NUCLEAR REGULATORY COMMISSION

Title: Advisory Committee on Reactor Safeguards
Plant License Renewal Subcommittee

Date: Wednesday, May 5, 2010

8 APPLICATION OF COOPER NUCLEAR STATION

Torus Pitting Depth Rate

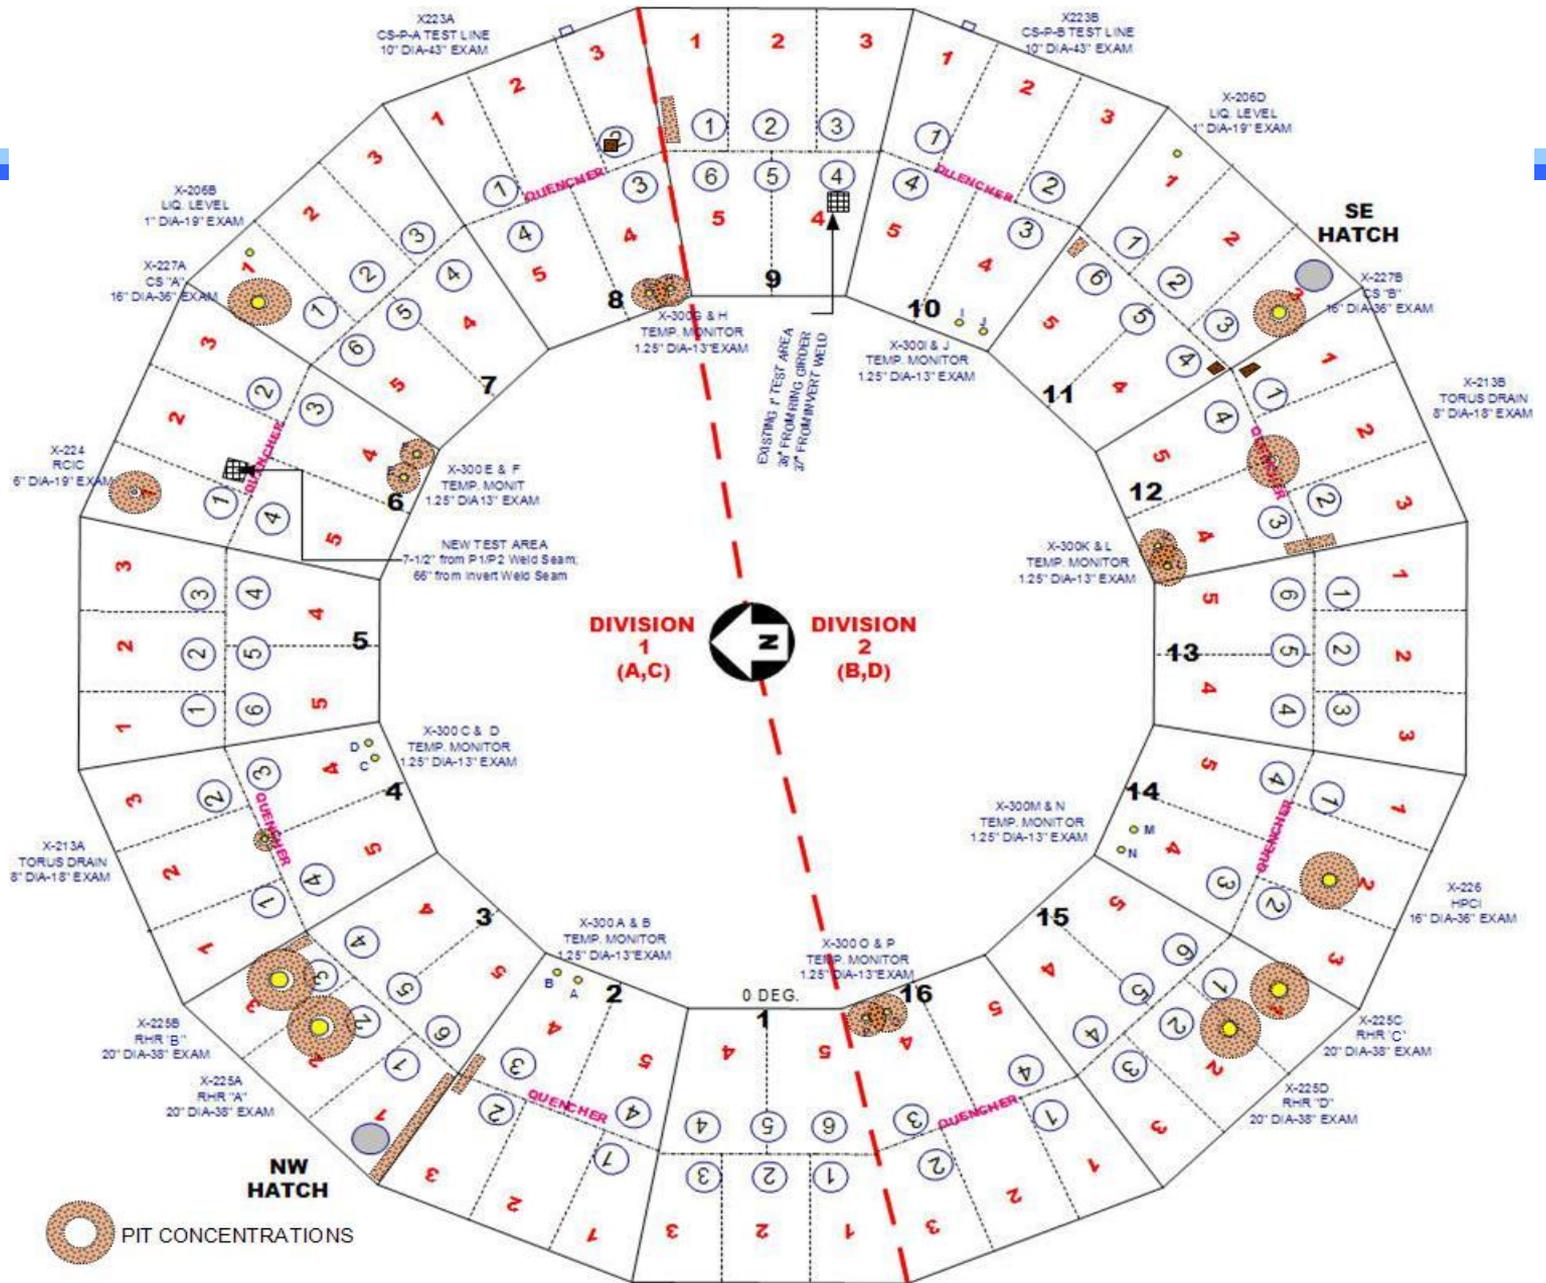
4 MEMBER ARMIJO: I have to ask you, did
5 you agree with the applicant's data that is
6 represented here on pit depth as a function of years
7 of operation, basically it's their figure - well,
8 there is no page number, but it's their figure showing
9 the mean depth and then also the 95 percent I guess,
10 95 percent - it's a mean plus two sigma line.

12 MEMBER ARMIJO: Because the question I
13 have is, on the page - their chart 35, they say the
14 maximum torus pit depth was 92 mils, which is much
15 larger than the two sigma maximum on this chart. So -
16 and it's the deepest pit that is going to cause some
17 grief. So how does that all come together and how
18 does the staff interpret that?

2 MR. SHEIK: I agree, we received this
3 information a few days ago and we haven't looked at it
4 in detail.

17 MR. TRAN: Well, we do believe that the
18 margin rate could be very uncertain, unpredictable.
19 So we have to look at it very closely to see whether
20 we could agree. We didn't have the time to provide it
21 to you this morning.
